## **Core Bus Corridor 2: Swords**

16th December 2020

Figure 2 Guidance Graph on Buffer Widths for Cycle Lanes from NTA National Cycling Manual

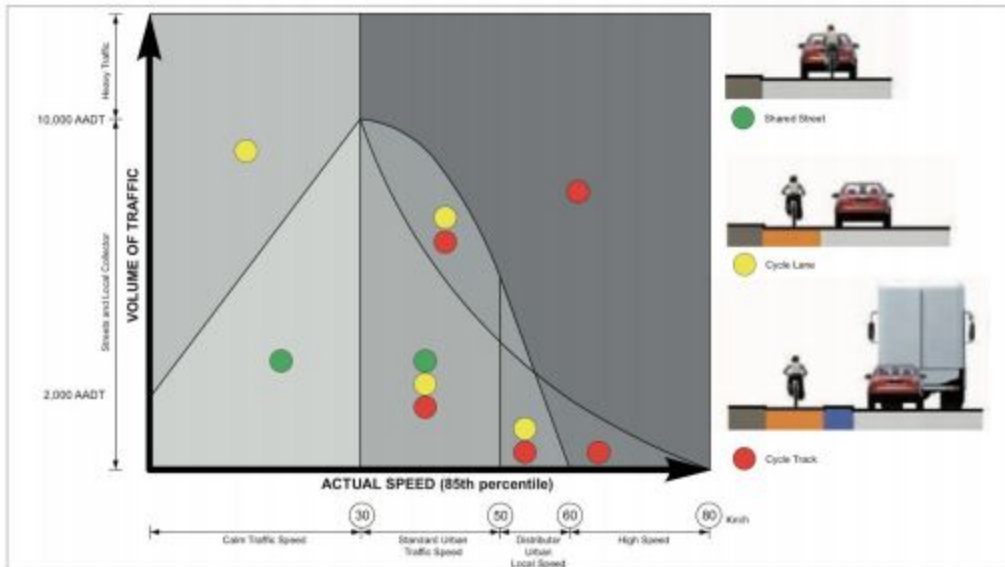
- The NTA’s National Cycle Manual (NCM), section 1.7.4, requires that there is a buffer space of either a hard paved area or grass verge between the cycle track and the roadway when the AADT and 85th percentile speeds are both high, such as Swords Road. This buffer space increases the comfort level for cyclists (one of the five needs of a cyclist). It also allows for overtaking using the full width of the cycle track, without partially overhanging the adjacent lane. We encourage the design team to, where possible, match the design of “Cycle Track Behind Verge” on page 67 of the NCM, which has grass/planted buffer between the cycle track and the road.

There is no guidance within the NCM for the size of this buffer space (the area marked in blue in the cycle track image above). However, this design guidance from the UK maybe useful: UK Interim Advice Note 195/16 for Cycle Traffic and the Strategic Road Network.
